SUNNYVALE WATER POLLUTION CONTROL PLANT PRIMARY TREATMENT FACILITY PROJECT

Addendum - Project Modifications

Prepared for
City of Sunnyvale

May 2017

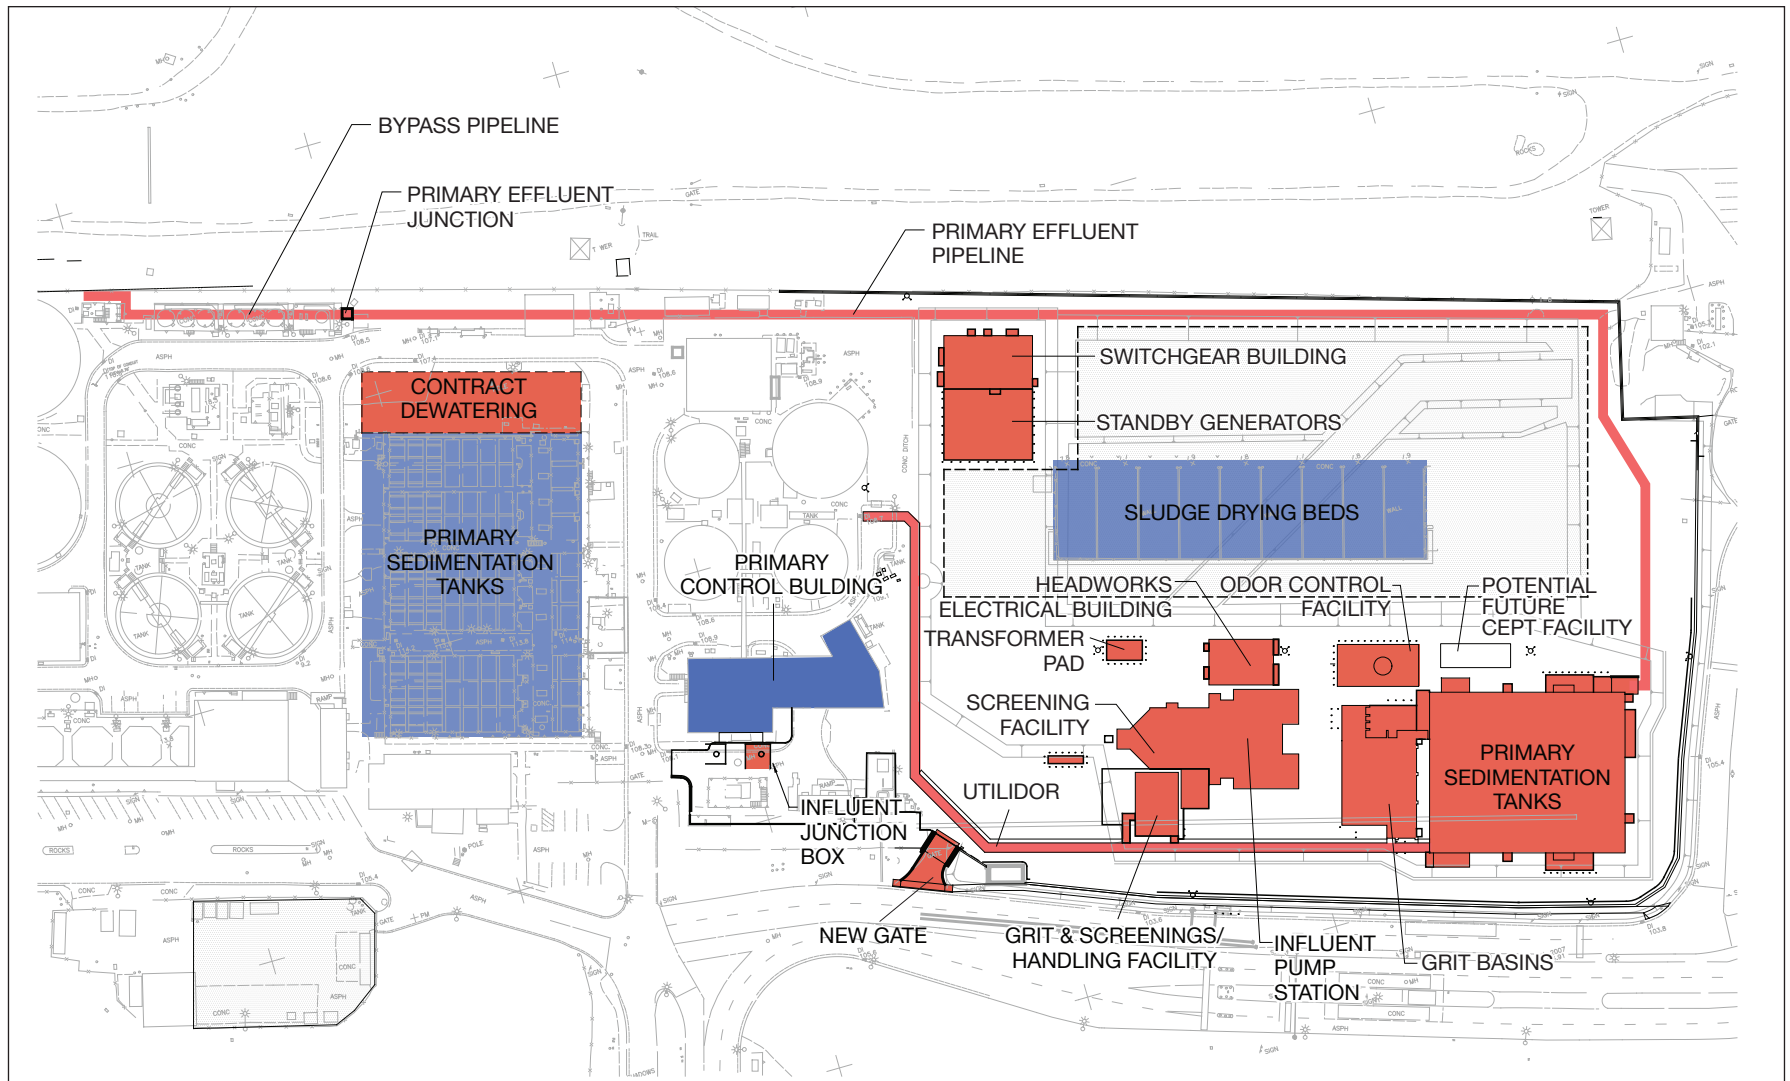
Note: Project modifications include changes to Odor Control Facility, elimination of Primary Effluent Pipeline segment extending along east side of Primary Sedimentation Tanks and addition of Bypass Pipeline. The City will decide whether to implement the CEPT Facility in the future (e.g., when determining improvements to secondary treatment facilities).

- **Primary Effluent Pipeline and Pipeline Junctions.** The Primary Effluent Junction Structure would be part of the PSTs. The Primary Effluent Pipeline would be constructed starting from the north side of the new PSTs, instead of from the southeastern corner of the PSTs; as a result, the total length of new Primary Effluent pipeline constructed would decrease by about 100 feet relative to the IS/MND project. Instead of being a concrete box, the Primary Effluent Pipeline Junction at the western end of the plant site would be a buried four-way pipe intersection with a concrete slab at grade. The project with modifications also includes a 200-foot long, 48-inch bypass pipeline between the new Primary Effluent Junction and an existing drainage pump station. The purpose of the pipeline is to bypass the existing pipeline that conveys flows to the ponds in the event of an emergency and instead convey flows to the ponds via an existing pipeline that discharges process overflow, tank drainage and site drainage to the ponds.

- **Utility Corridor.** Instead of the previously proposed utility tunnel connecting the new primary sedimentation tanks to the existing digester complex, a utility corridor consisting of a covered concrete pipe trench (“utilidor”) would be installed to connect these facilities.

The switchgear building and distribution system would be installed as described in the IS/MND. The standby generators area would be in the same location as identified in the IS/MND, but the orientation of the generators would be rotated approximately 90 degrees and the entire area shown in Figure 2 paved with concrete.
